APPLICATION REF: PL/2025/09973

ADDRESS: PORTWAY HOUSE, OLD SARUM PARK, OLD SARUM, SALISBURY SP4 6EB

We are writing on behalf of South Portway Management Company to object to the current proposal at Portway House submitted by Wessex Archaeology. The application seeks prior approval for change of use of Class E space to form 20 apartments, falling under Use Class C3. Our clients have strong concerns in relation to a number of matters, set out within this letter.

Figure 1 - Aerial photo

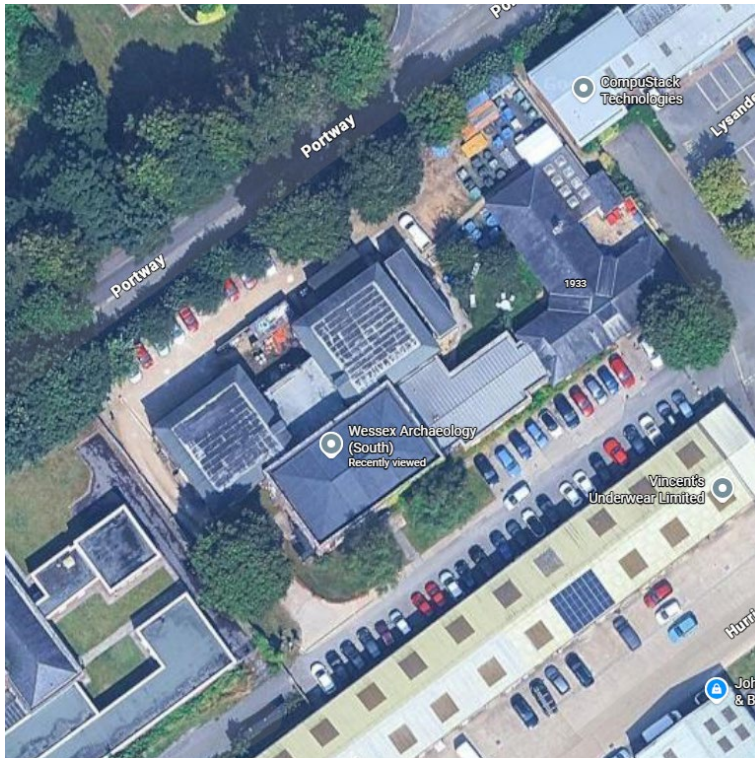
Aerial photography of the site demonstrates that only around 45 cars can be parked across both the front and rear of the buildings:

However, these are not in marked bays which provide the sufficient turning and aisle space required for manoeuvring. Indeed, the gap retained between these cars (bonnet to bonnet) is only around 4m, and the distance between the cars and the footway leading to the entrance to the building is only around 3m, neither of which is sufficient for formal parking. It is anticipated that this is why all cars have parked in reverse, as it is only possible to exit such constrained parking spaces in a forward gear.

Figure 2 - Block Plan with available space annotated

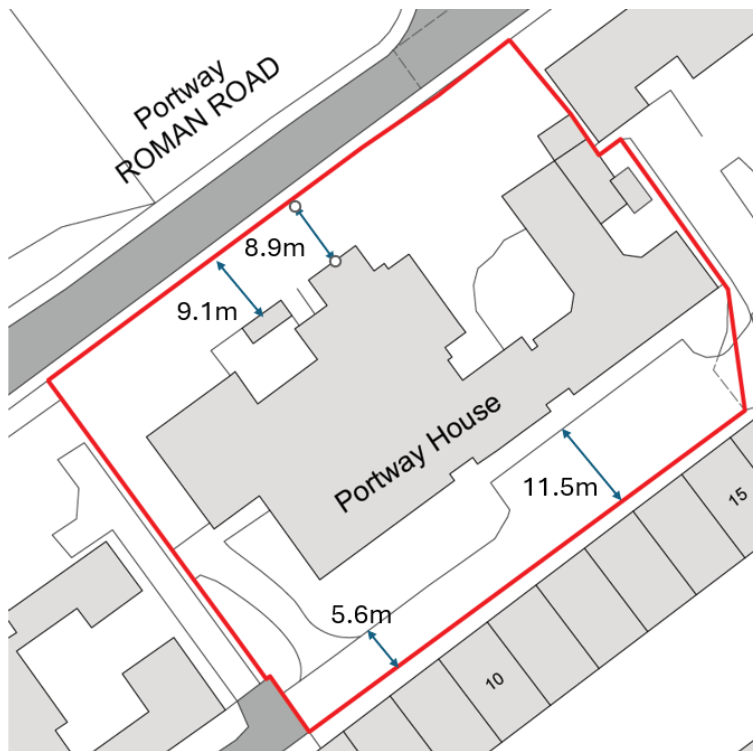
Both the topographic survey and the Block Plan demonstrate that it is evident there is not sufficient space available for suitable parking in front of the building as suggested.

Standard parking bays should be 2.4m x 4.8m in size, with an aisle width of 6m for manoeuvring in and out of the space. This can be achieved at only a small section of the site in front of the building which has a depth of 11.5m, amounting to around 10 parking spaces, but nowhere else along the building frontage.

Figure 4 - Topo survey extract of the rear of the site

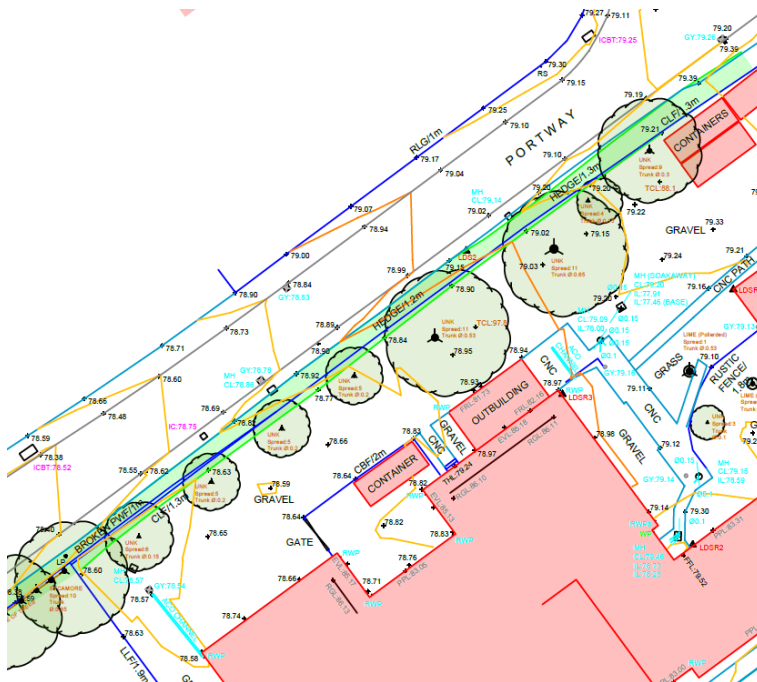
To the rear of the site there is some room for parking, however firstly even if the full extent of the site could provide a row of parking spaces, this would only amount to approximately 29 spaces. However, as with the front of the building, there are areas where the sufficient aisle widths cannot be achieved, in turn greatly reducing the areas that can be used for parking. There are also additional constraints to the rear of the site, including mature trees, which further restrict parking spaces.

At no point to the rear of the building are the depths great enough to allow for two rows of parking. Therefore, the greatest number that could be achieved to the rear of the site is 10 parking spaces.
